GFA AIRWORTHINESS DIRECTIVE

TYPE AFFECTED: PW-6U Serial no.s 78.02.07 to 78.02.10 and 78.03.01 to 78.03.03

SUBJECT: Inspection of push rod ends installed in aileron spoiler and elevator drives.

MANDATORY BULLETIN No. BO-78-03-06

Sketch 1: Push-rod end

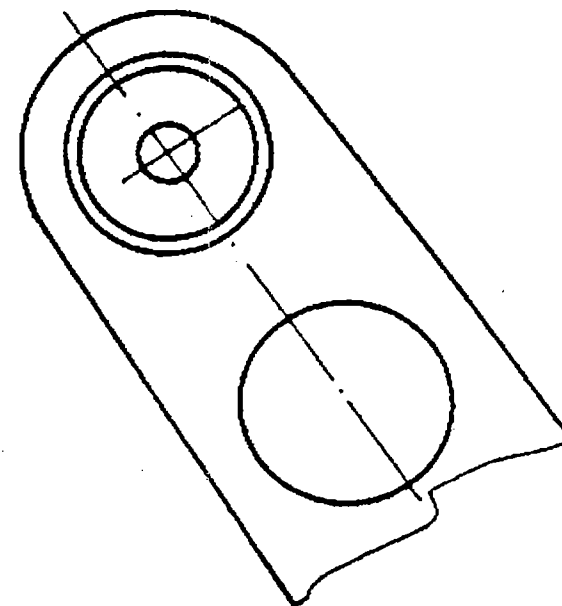
In relation to a case of exceeding the minimum dimension of the push-rod end S/N 78.21.215.00.00, it is required to make the measurement of all ends installed in the PW-6U sailplane in accordance with the Sketch No. 1 enclosed to this bulletin. The ends are installed in wings in the aileron control system and in the air brakes (altogether 5 pcs per sailplane).

This bulletin is intended to advise the PW-6U sailplane operators that if the dimension defined on the sketch is found to be less than 4.2 mm, the flights should be discontinued and the sailplane must be parked until a particular push-rod end is replaced with a new one.

$A_{\text{Minimum}} = 4.2 \text{ mm}$

Inspect push-rod ends in the following sailplane control systems:

1. Aileron control system (L/H, R/H)
2. Air brake control system (L/H, R/H)
3. Elevator control system

The activities related with measurement of ends shall be performed by the sailplane operator. In case the measured parameter is less than the acceptable one, a new end must be ordered. For this purpose, send the following information to „PZL-Świdnik” S.A. onto the fax No. (+48 81) 468 09 18: sailplane S/N, location of the end installation and measurement result. This shall be the basis for the free-of-charge ordering of a new end at „PZL-Świdnik” S.A. The sailplane manufacturer shall deliver, at his own expense, the new ends S/N 78.21.215.00.00 and the retaining washers preventing the ends against loosening. The ends shall be replaced with new ones by the operator at his own expense.
